Re: 798 塞尔维亚文化处项目图纸及设计要求的疑问

Questions on drawing and design of "the Cultural Center of the Republic of Serbia in Beijing" tender documents

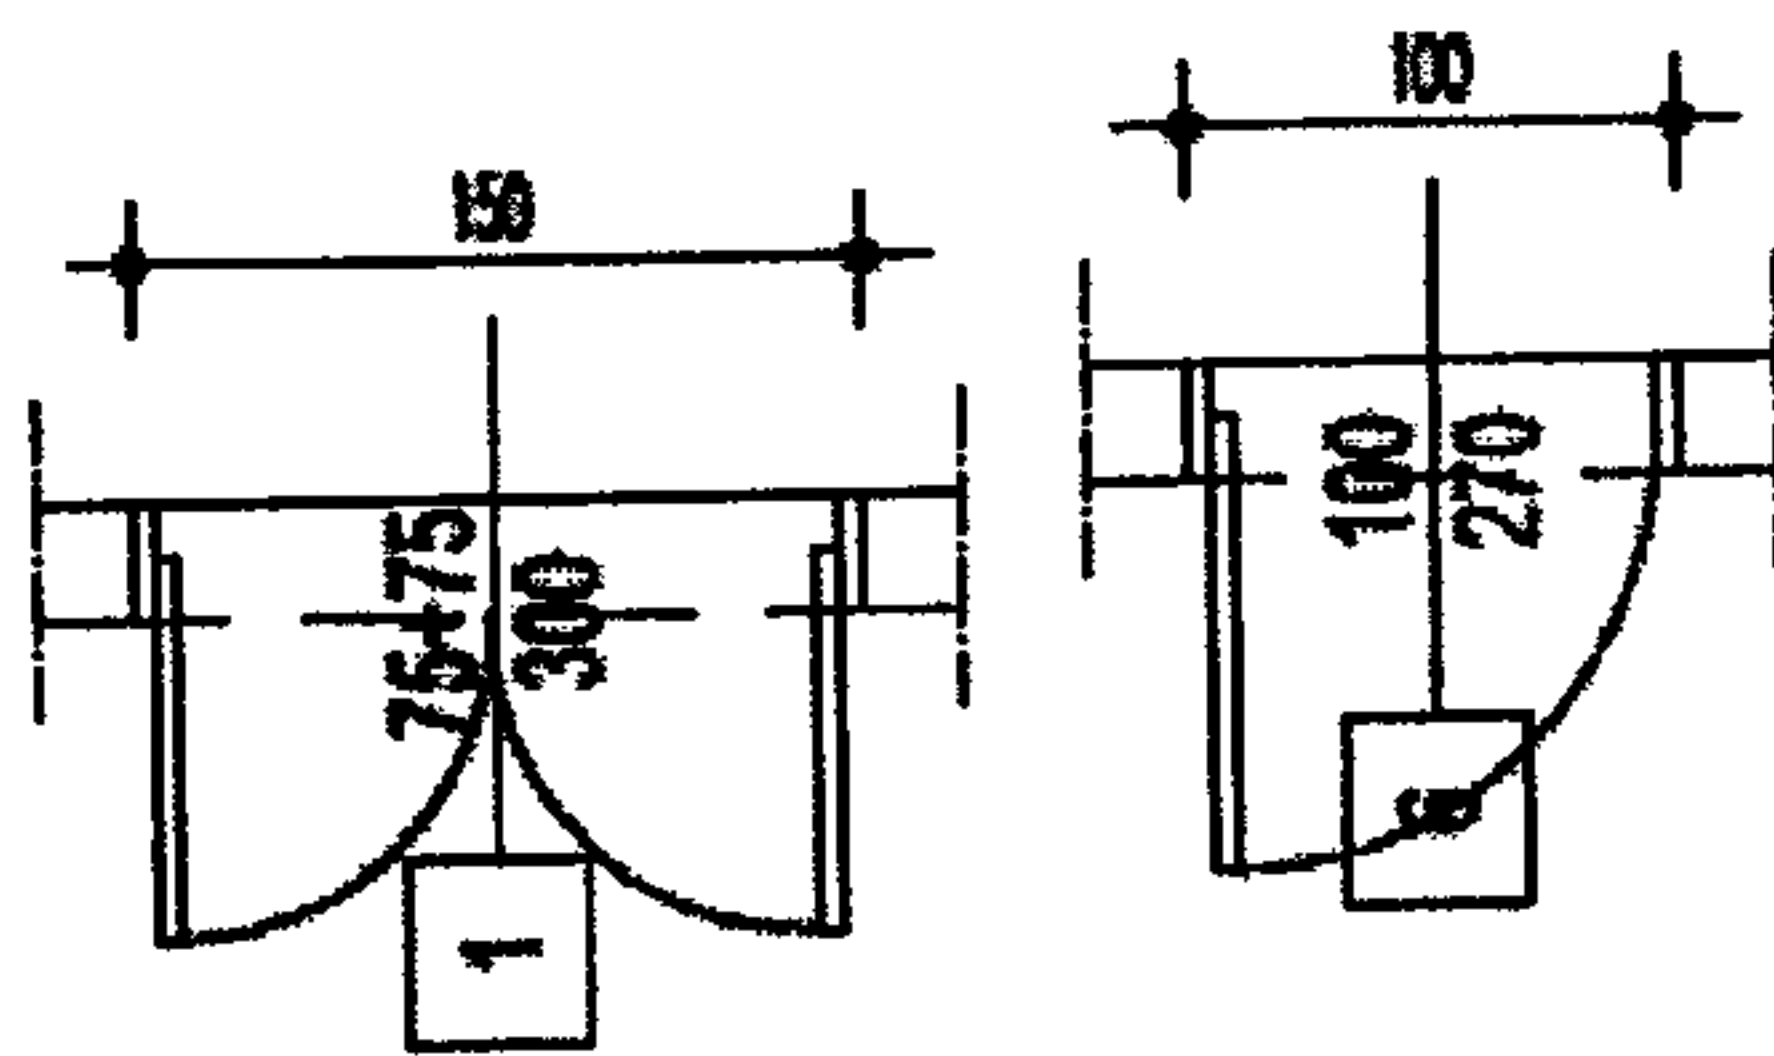
8. 窗编号 4，图纸右侧一层新开窗，现场没有窗，按物业要求不可动外立面，是否确认

Regarding to the window no.4 in drawing, it is a new window in 1st floor, but this window on site doesn't exist, according to regulation of building management, it can't be changed for façade.
